REVISION OF CITY OF
BEAVERTON STANDARD
DRAWING NO. 309
7-13-04

**ATTENTION! THIS DRAWING REPLACES
DRAWING NO. 309, DATED 6-10-04**

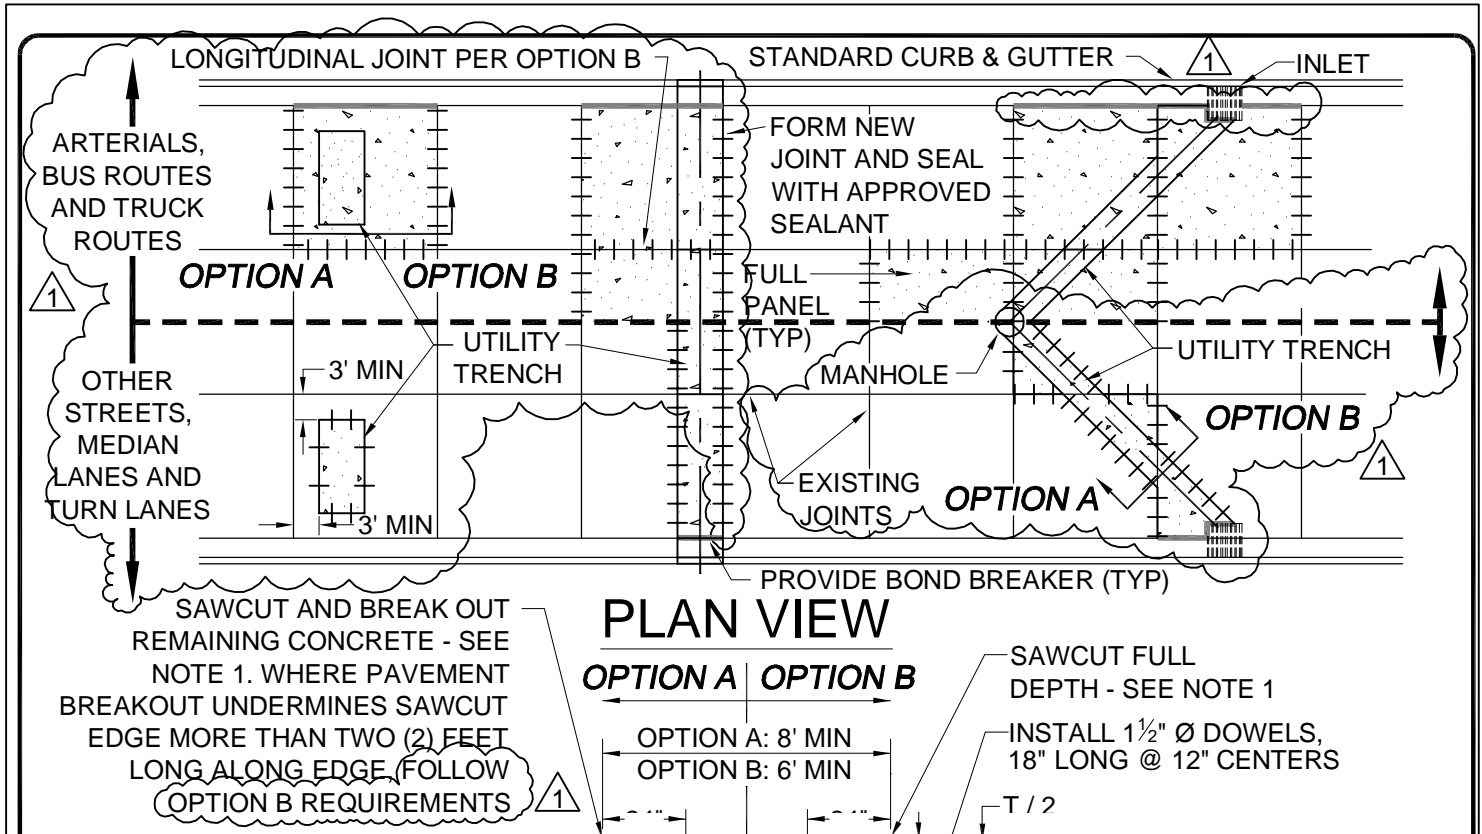
△ ADDED CALL-OUT "LONGITUDINAL JOINT PER OPTION B" TO PLAN VIEW. REVISED GRAPHICAL REPRESENTATION FOR UTILITY TRENCHES CONTAINED ENTIRELY WITHIN ONE PCC PAVEMENT PANEL. ADDED SHADED LINE FOR BOND BREAKER ON CURB JOINT. ADDED A-B SECTION LINE TO "ARTERIALS, BUS ROUTES AND TRUCK ROUTES" HALF OF PLAN VIEW. REVISED CATCH BASIN AND LEADER IN "OTHER STREETS, MEDIAN LANES AND TURN LANES" HALF OF PLAN VIEW. CHANGED THE SAWCUT DEPTH TO T/3 FROM T/4, AND ADDED "SEAL THE NEW JOINTS PER THE ENGINEERING DESIGN MANUAL," TO NOTE #6. ADDED "FOLLOW OPTION B REQUIREMENTS" TO CALL-OUT FOR "SAWCUT FULL DEPTH AND INSTALL 1 ½" Ø DOWEL, 18" LONG @ 18" CENTERS."
